Preliminary Consultation
MONTGOMERY COUNTY HISTORIC PRESERVATION COMMISSION
STAFF REPORT

Address:	6801 Westmoreland Ave.	Meeting Date:	02/22/17
Resource:	Contributing Resource Takoma Park Historic District	Report Date:	02/15/17
Applicant:	Mauricio Mateos	Public Notice:	02/08/17
Review:	Preliminary Review	Tax Credit:	n/a
Case Number:	n/a	Staff:	Dan Bruechert
Proposal:	Rear addition, windows, siding, and other changes

HISTORIC PRESERVATION COMMISSION STAFF REPORT

Address:	6801 Westmoreland Ave., Takoma Park	Meeting Date:	01/11/17
Applicant:	MDS Investments, LLC	Report Date:	01/04/17
Resource:	Contributing Resource Takoma Park Historic District	Public Notice:	12/28/16
Review:	HAWP	Tax Credit:	n/a
Case Number:	37/03-17A	Staff:	Dan Bruechert

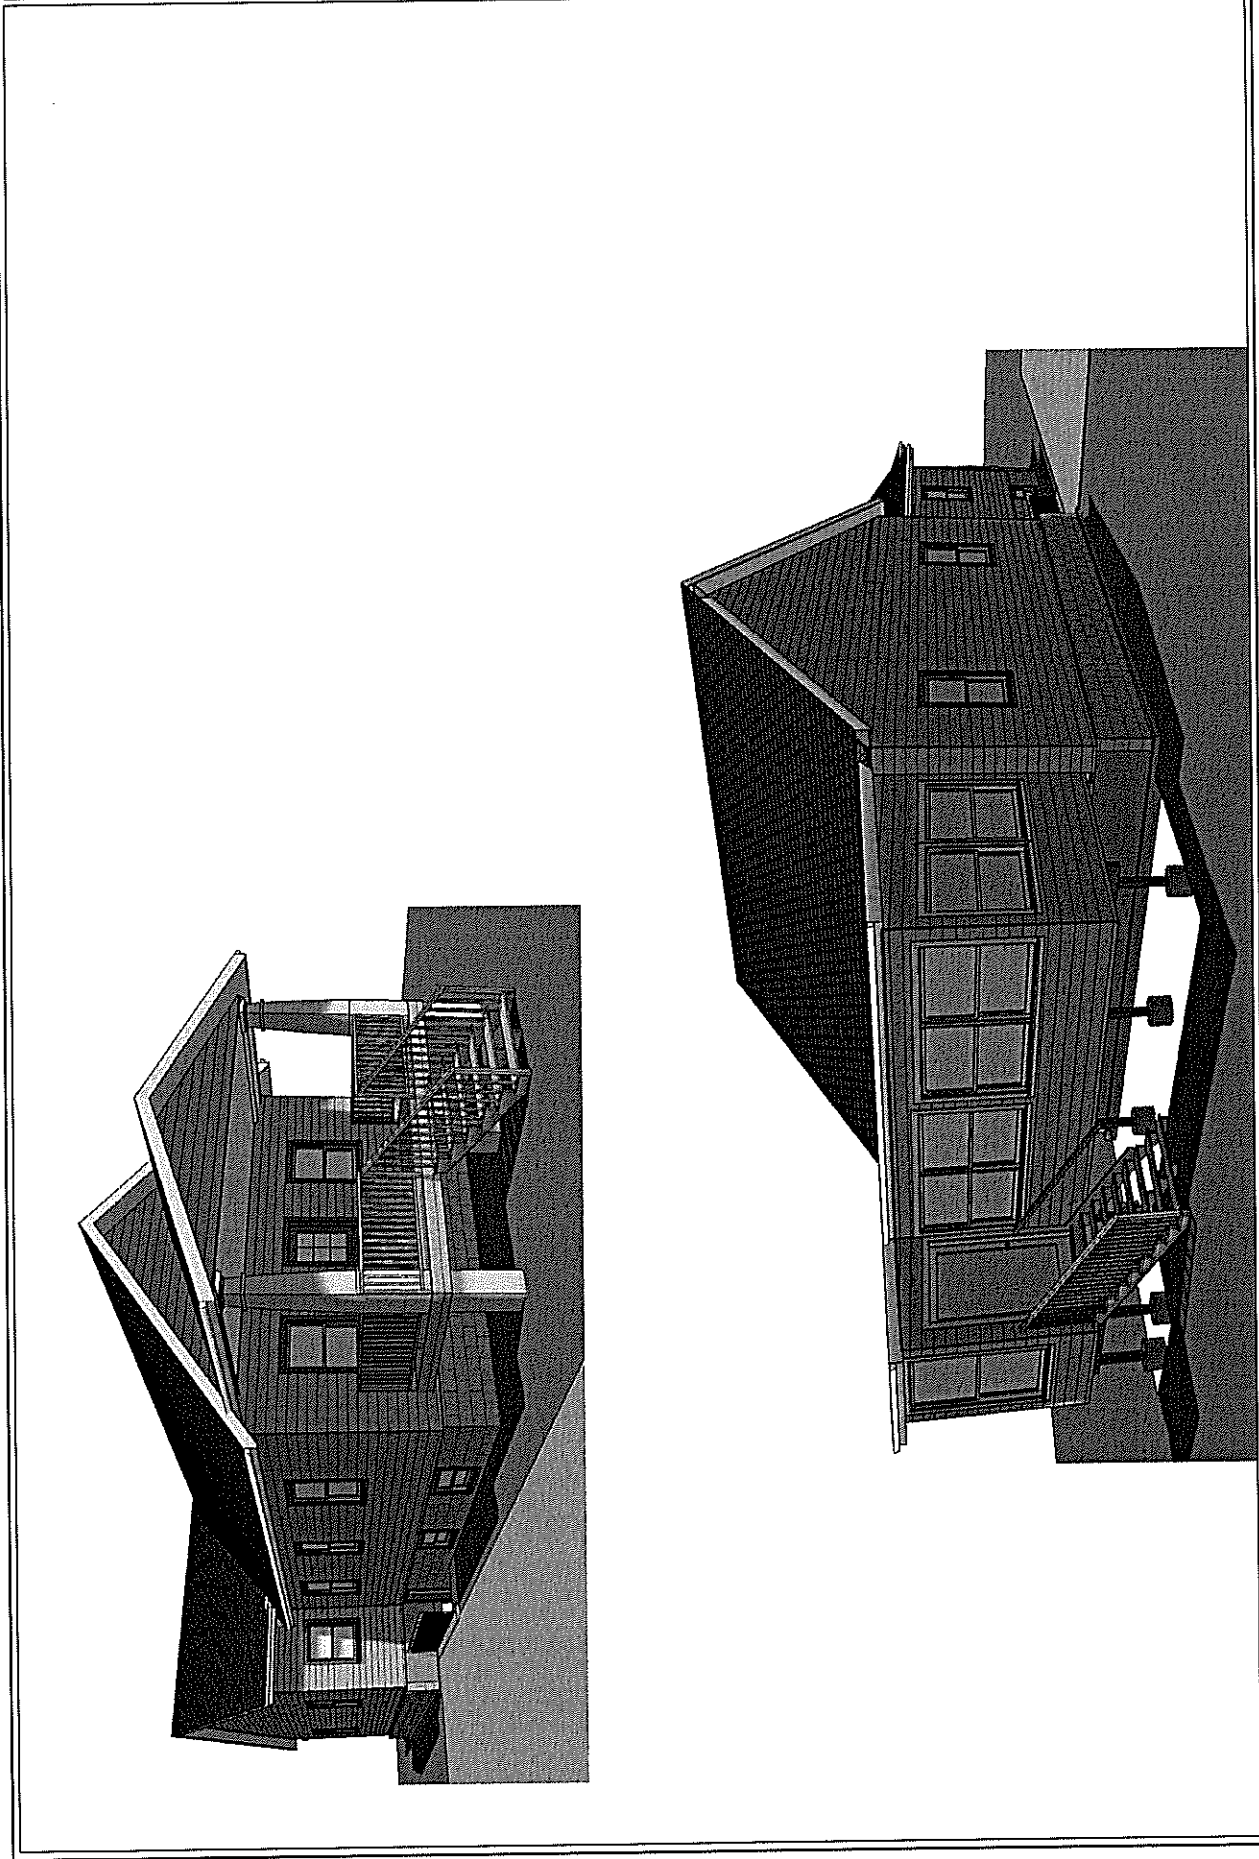
The applicant's proposal will largely retain the historic form of 6801 Westmoreland Ave. The proposal calls for the construction of a side-gable addition to the rear with a sunroom topped by a shed roof off the back of side gable addition. This general form is not uncommon. However, the proposal would have the effect of more than doubling the building footprint (this historic core of the house is 31' deep × 24' wide, and the addition is 30' deep × 24' wide with an additional 10' of depth for the porch).

- In this instance does the HPC prefer a one-story addition with a larger footprint or does it feel that a two-story addition with a smaller footprint would be more appropriate for the surrounding district?

The side gable roof on the addition appears to have a taller ridgeline than the historic building. As the Design Guidelines address the potential of second floor additions, the Commission could find that it would be acceptable to have a taller addition at the rear is the proposed side gable addition is otherwise compatible with the criteria for approval ("Second story additions or expansions should be generally consistent with the predominant architectural style and period of the resource...").

- What additional information does the HPC need to determine if the roof pitch and height covering the addition are appropriate?

The renderings also show a reconfigured front porch. The porch entrance has been moved from a side-loading to a front-loading porch. This change will not have a significant impact on how the building interacts with the streetscape and generally respects the setting of the house. Additionally, many of the porches in neighboring houses have front steps. The renderings provided do show a change in the pitch of the roof and the coverage of the front porch. If accurate, the renderings show that the historic wood brackets – one of the few remaining historic elements – would be removed to accommodate the new porch roof. While reviewing changes to 'contributing' resources are to focus on the impact to the streetscape and surrounding district, this proposal would alter one of the few historic features and would contravene 24A-8(b)(1). Staff recommends that, consistent with this criterion for approval, the form and historic materials found in the porch should be retained in a revised design and seeks the Commission's guidance on the front step reorientation and alterations to the wood brackets and porch roof.

- Is it appropriate to reorient the front steps and replace a concrete element with wood construction?

- What level of documentation does the HPC require to determine that the historic wood siding may be removed from the historic core of the house?
- Can the HPC provide guidance on the appropriate materials for both the historic core of the house and the associated additions?

There are no historic windows remaining at 6801 Westmoreland Ave. The images provided in the attached rendering show one-over-one sash windows. The simple details found on the house suggest that this is an appropriate configuration for the windows. Staff does recommend that the proposal does maintain the pattern and size of the historic window openings when installing replacement windows.

- What is the preferred material and configuration for replacement windows on the historic core of the building?
- What is the preferred material and configuration for windows in the addition?
